# ***Re-suggestion of PRX30 upstream wavelength range***

**Kengo Hirano  
NEC Corporation**

**IEEE 802.3av Munich meeting, May 13–15, 2008**

Figure 60-4—1000BASE-PX20-U transmitter spectral limits

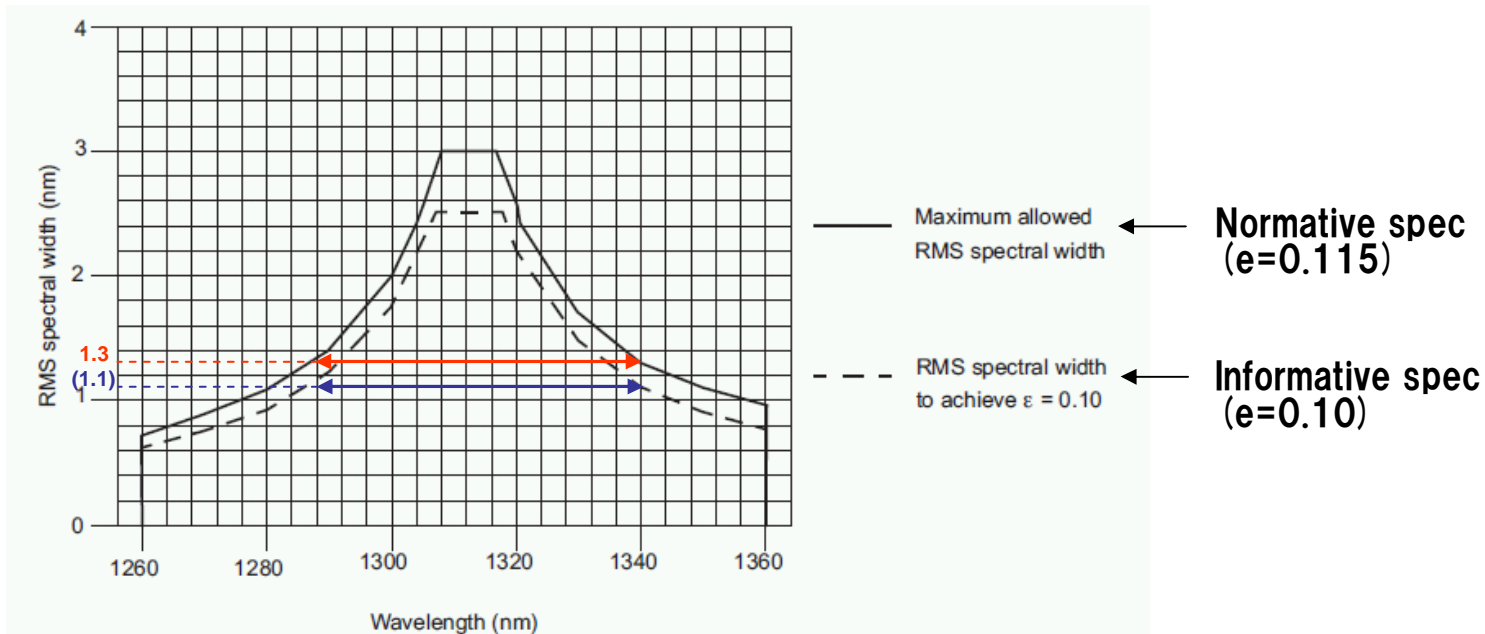
- ✓ 802.3ah PX20 (Fig.60-4) specifies the Tx spectral limits as follows.
- ✓ In this graph,  $e=0.115$  is employed to calculate the relation between the maximum allowed RMS spectral width and the wavelength.
- ✓  $e=0.115$  is also used in ITU-T for estimating MPN (Mode Partition Noise) penalty for FP-LD, which assumed to be less than 1 dB.

- ✓ However, it is very difficult to meet the PX20 spectral limits with FP-LD, considering actual temperature range.
- ✓ Indoor ONU needs the RMS spectral width of < 1.3 nm. (Outdoor is much smaller number !!)
- ✓ Commercially available FP-LD is > 2.0 nm at the least.
- ✓ Therefore, DFB-LD is inevitably needed for PX20 deployment.

Figure 91-6-10/1GBASE-PRX-U3 transmitter spectral limits

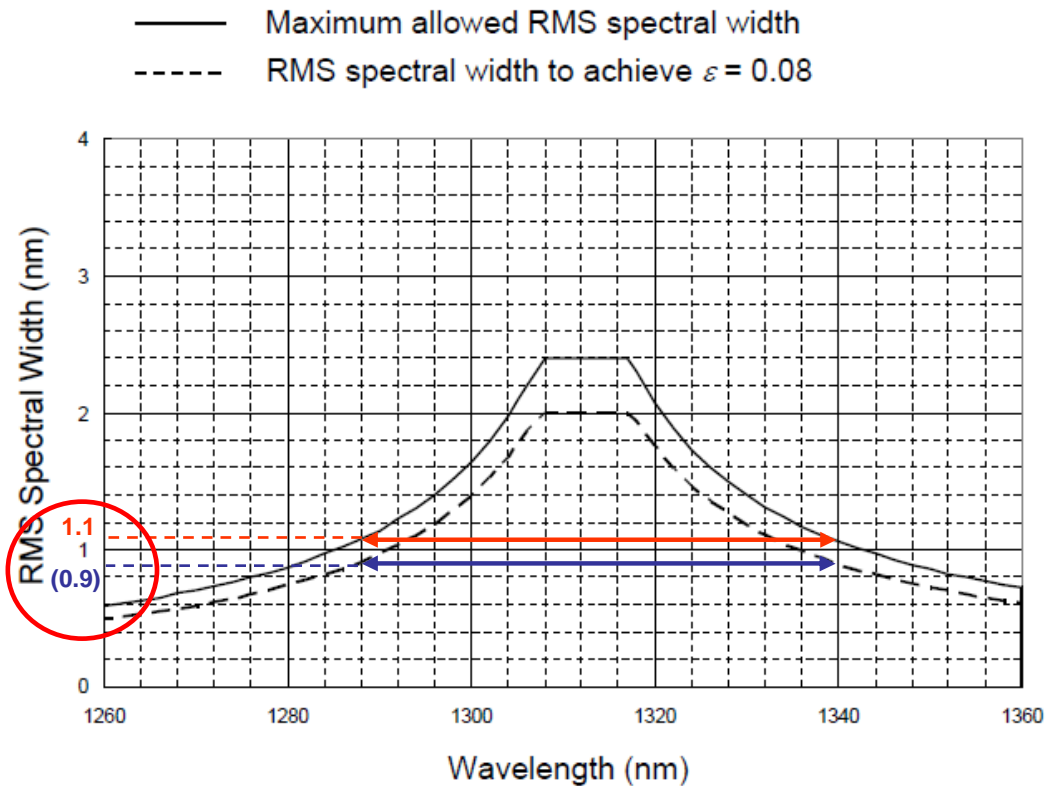
If Mr. Suzuki's material (3av\_0805\_suzuki\_1 [1].pdf) is used, it'll be the severer value.

## Wavelength Plans

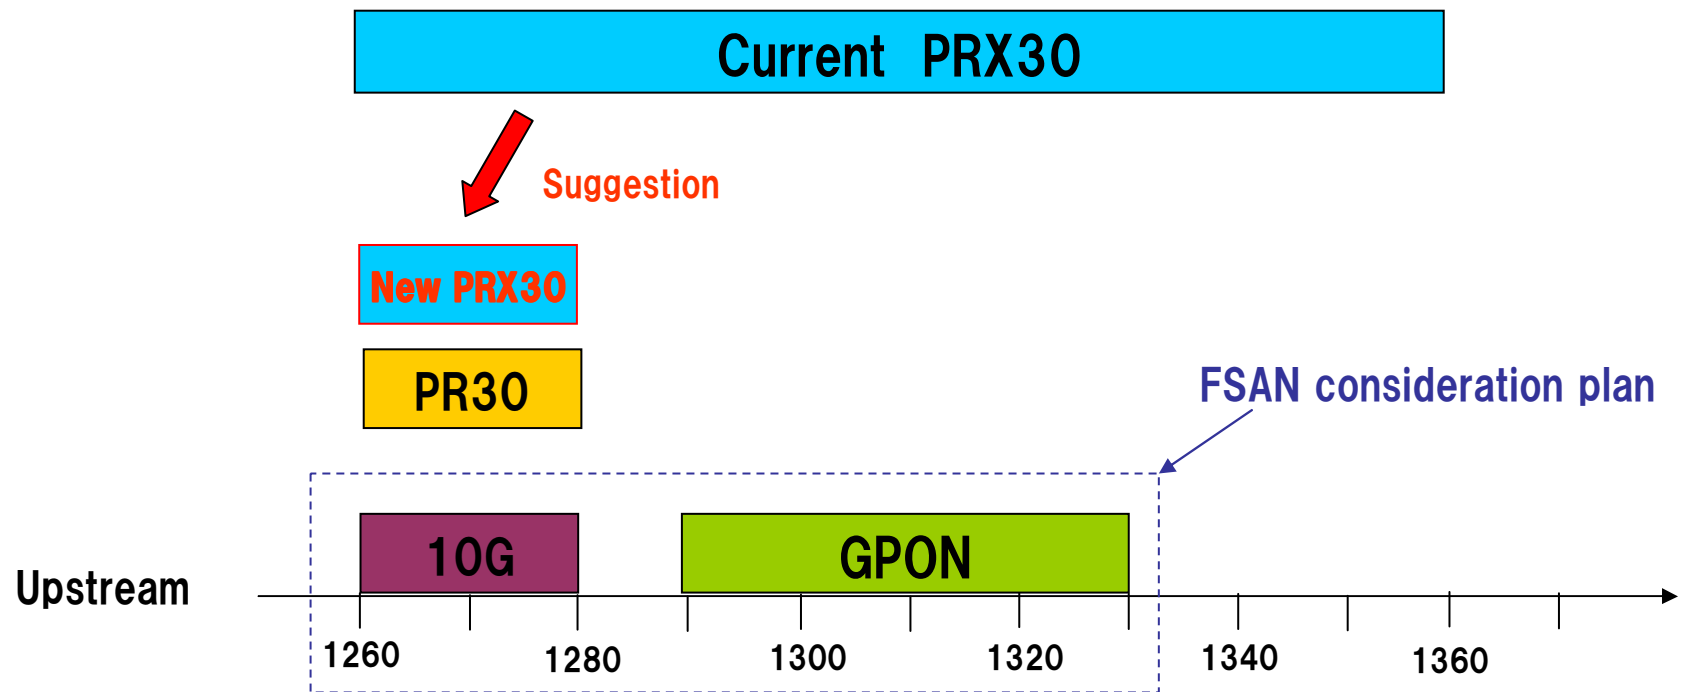
- ✓ If it is the same “1260–1289 nm” as PR30, it has good compatibility with FSAN/ITU-T. And It will be able to migration (i.e., asymmetry 10G to symmetry 10G) that smoothly.
- ✓ When this value is used, overlay with GPON becomes possible by WDM.

Change of the PRX30 upstream wavelength range  
 「1260–1360nm」→「1260–**1280nm**」
